Comment 88 to 802.1ASdm d0.5

Scope of the LocalClock entity

Martin Ostertag, Zurich University of Applied Sciences

Two Instances A,B with LocalClock entity from different oscillators

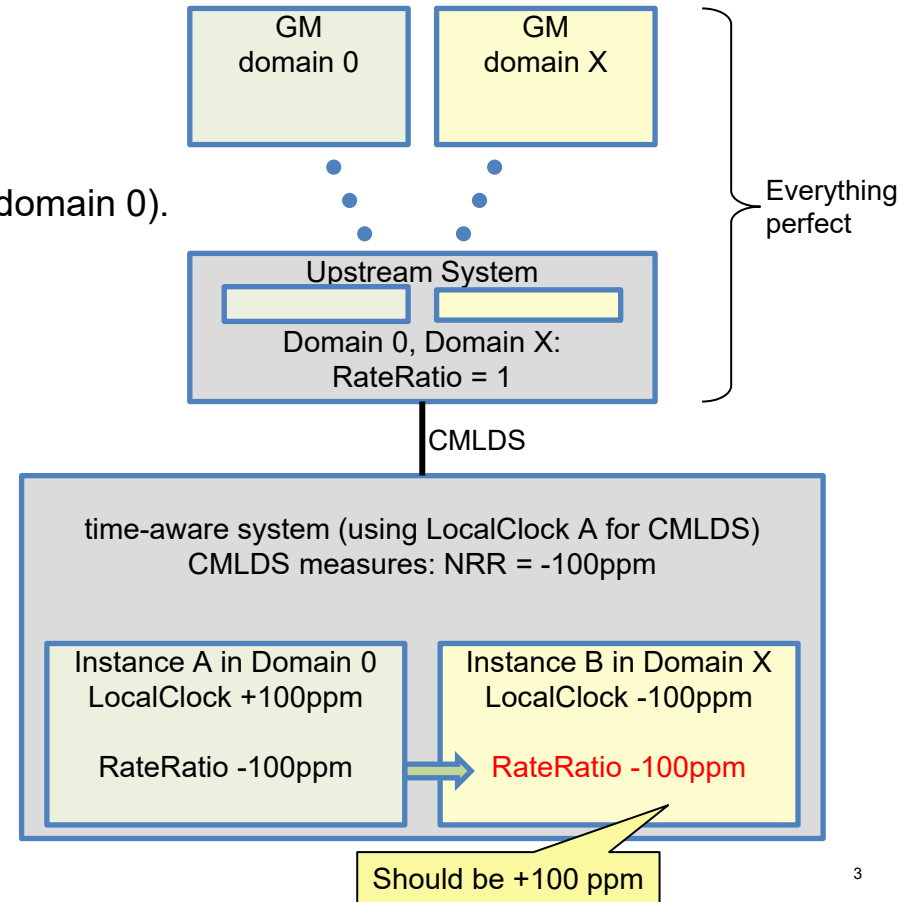
Instance A: domain 0, Instance B: domain X

- LocalClock A **+100ppm** relative to GM
- LocalClock B **-100ppm** relative to GM

All upstream clocks and time-aware systems perfect.

Link Delay measurement with CMLDS and LocalClock A (for domain 0).

Let the true residence time be 10 ms, LinkDelay is ignored

Domain 0	Domain 1
LocalClock Rate	+100ppm	-100ppm
NRR (from CMLDS)	0.9999 (-100 ppm)	0.9999 (-100ppm)
Calculated Rate Ratio	0.9999 (-100 ppm)	0.9999 (-100ppm)
"True" RateRatio	0.9999 (-100 ppm)	1.0001 (+100ppm)
Measured Residence Time	10.001 ms	9.999 ms
Scaled with RR, added to Correction Field	10.000 ms	9.998 ms
Error	0	2 μs

Proposed Resolution (different from comment 88)

- **Align the definitions and define there is one LocalClock entity per time-aware system**
- **Requires changes in 8.6.2.2 of 802.1AS-2020 and the note in 802.1ASdm d0.5**
 - This definition is already present in the media-independent definitions (10.2.5.7, 10.2.5.8)
 - In 802.1AS-2011 there was only one instance with domain 0, so in practice there was always only one LocalClock in a time-aware system
